## E8803A-02

# S E R V I C E N O T E

## E8803A PNA Microwave Network Analyzers

**Figure 1:** A3 Front Panel Interface Board Assy without the Bracket

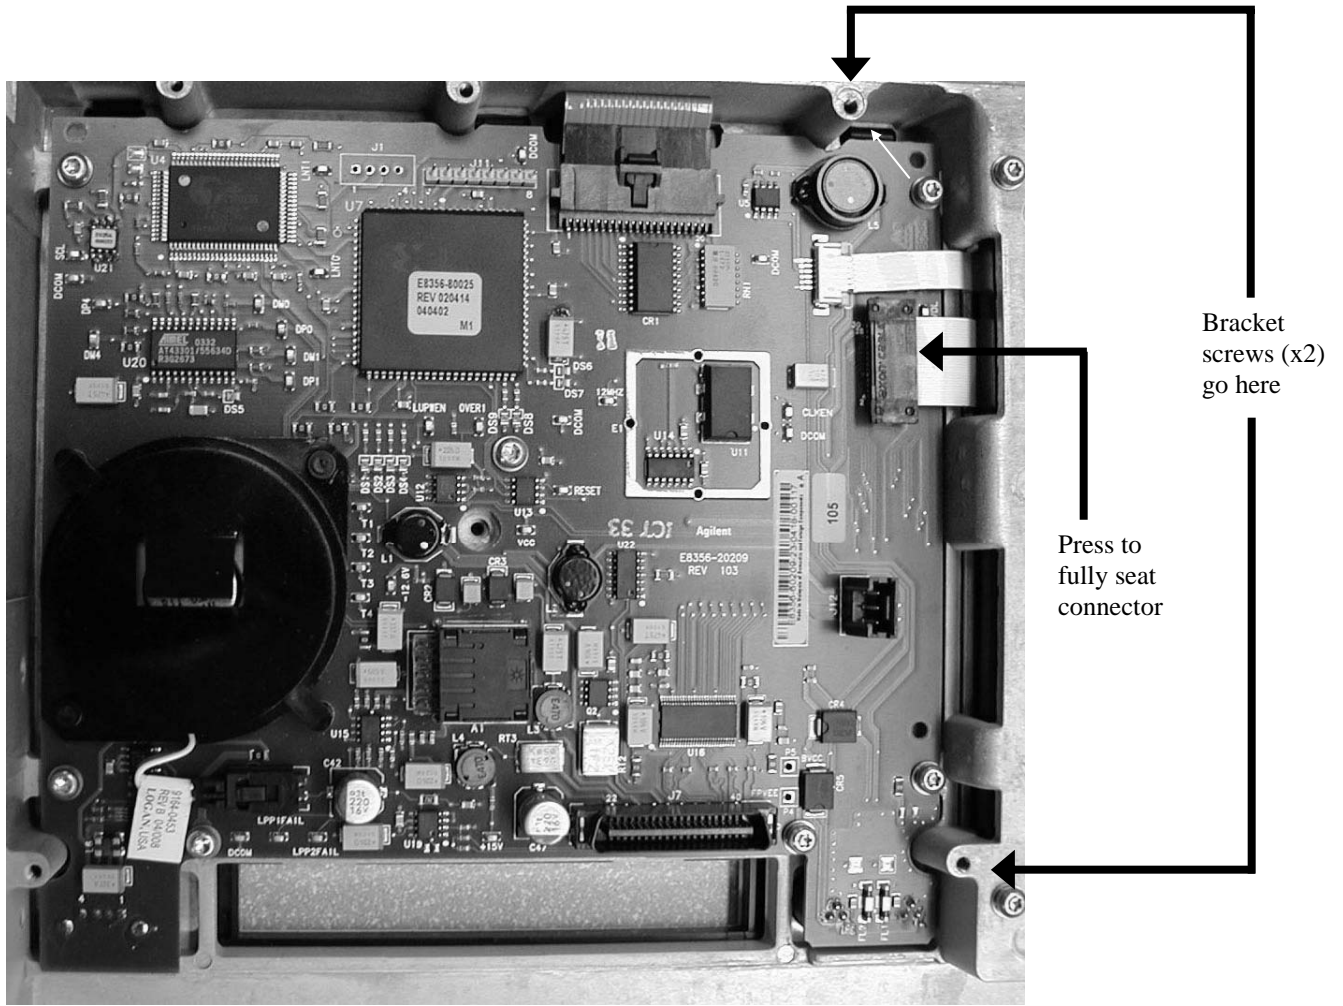
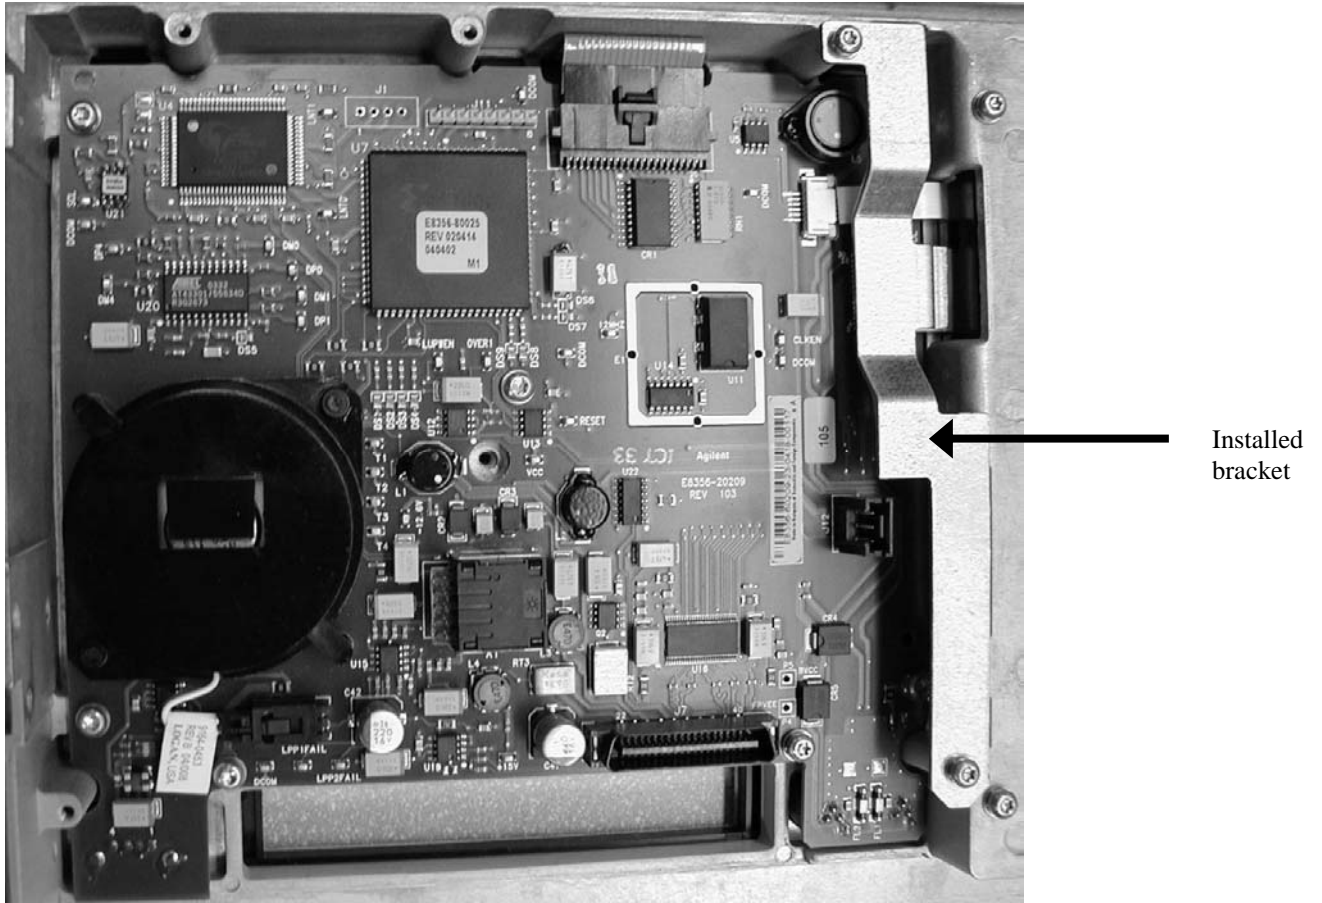
A connector of the ribbon cable (Agilent part number 8120-8409) that joins the front panel display to the front panel interface board can loosen, causing a display failure, unless a new bracket is installed. Because the failure rate has been very low, it is recommended that the bracket be installed only when there is an additional reason to remove the PNA front panel.

1. Refer to Figure 1 in this document:
  - Press down firmly on the ribbon cable's black connector.
  - Locate the two tapped holes for the bracket screws.
2. As shown in Figure 2 in this document, position the bracket so that its holes line-up with the two holes you located in the previous step.
3. Hand-start the two screws, and then torque both to 9 in-lbs.
4. Reinstall the PNA Front Panel by following the Service Guide instructions in the "Replacement Procedure." This is located on the same page as the "Removal Procedure" used previously in step 7.
